Thakeham Mushrooms, Storrington Road, Thakeham, Pulborough –Planning Application DC/26/0266

Table 1: Response to Horsham District Council Planning Department dated 26th March 2026

Table 2: Response to NatureSpace dated 26th March 2026

Butterfly Bank

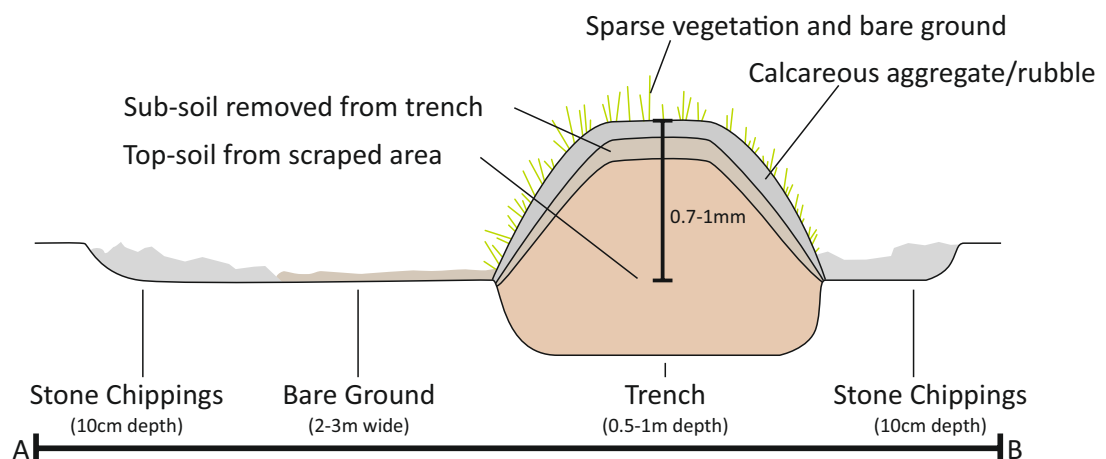
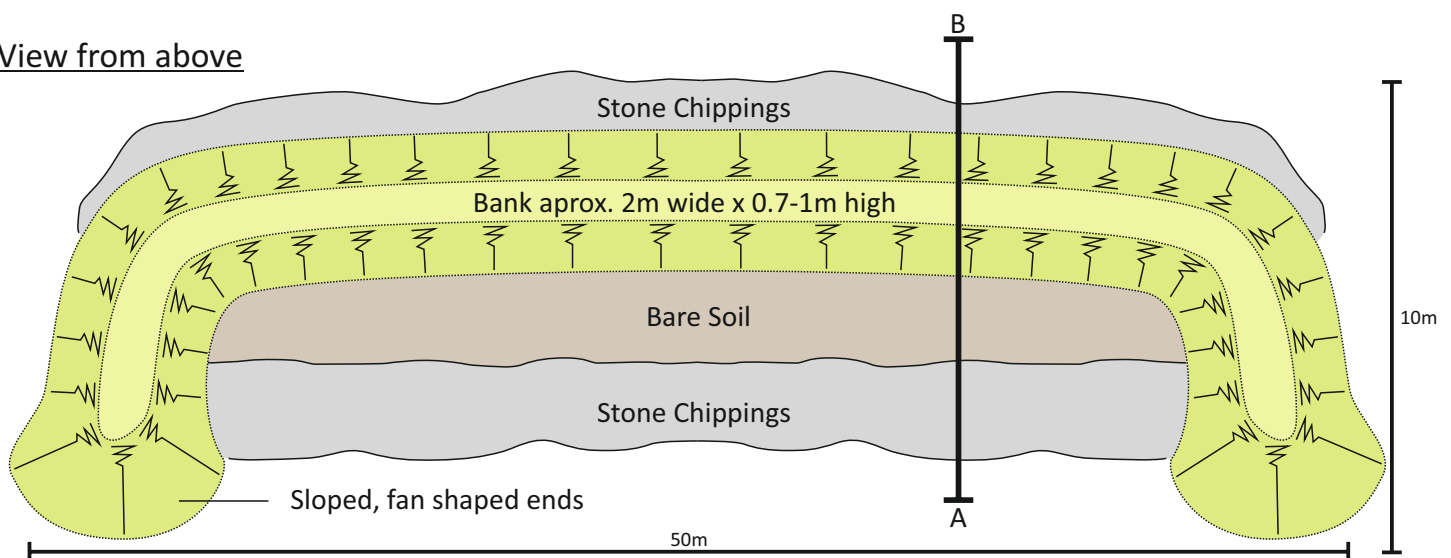
“Given the scarcity (particularly in the southeast) and high cost of OMH units on the BNG market, HDC will need further assurance that this is deliverable and will meet the JNCC priority habitat description. Further information is requested on why this habitat cannot be retained. Furthermore,	The onsite area of OMH unfortunately cannot be retained within the site, as work to remove adjacent areas of hardstanding cannot be guaranteed to not damage/destroy the onsite OMH. However, given the size of the existing onsite OMH, only a very small area of OMH creation is required within the site, which is readily achievable (delivered in the form of a butterfly bank).

the current proposal of a ‘butterfly bank’ will not be sufficient as currently described, and it is recommended that any proposed OMH accord with the guidance set out in the West Midlands Combined Authority ‘Brownfield Habitats and Biodiversity Net Gain’ note to meet the priority habitat criteria. Specifically, we want to ensure that the soil will remain nutrient poor, and soil substrates, aspects, topography and hydrology will be varied across the habitat to ensure structural diversity and a mosaic of habitats with different microclimates. No topsoil should be introduced to this area, and it is likely that the upper layer of existing soil will need to be removed and replaced with waste materials, or other friable/aggregate material if the former is not possible. A detailed drawing and material and species composition alongside long-term management will be expected in any forthcoming HMMP. Confirmation is also requested on whether screening or fencing will be implemented along the western boundary to ensure the larger off-site OMH parcel is not subject to heavy recreation.”	In terms of the substrate to be utilised, we can confirm that any topsoil utilised will be buried deep within the butterfly bank, such that suitable species rich grasslands and colonising vegetation will dominate the bank, with bare and exposed soils/gravel adjacent to the bank. Indeed, given the volume of concrete and brick material currently present within the site, it is envisioned that such material can be broken down and incorporated within the bund to ensure the substrate is nutrient poor. An example butterfly bank design is appended to this letter. Finally, with respect to the western boundary treatment, a post and rail fence will be installed.

Butterfly banks provide breeding opportunities and enhance connectivity between habitats for a range of butterfly and moth species and other invertebrates.

Butterfly banks are sparsely vegetated mounds, ideally created on nutrient poor substrates, which support a mosaic of early successional herbs and bare ground. The bank can also be designed to reduce nutrients through burying of topsoil as described below.

Butterfly banks should be situated in a sheltered area where an unshaded, south-facing bank can be created, as well as a variety of other aspects (through designing the bank in a 'C' shape) creating different temperate conditions and microclimates.
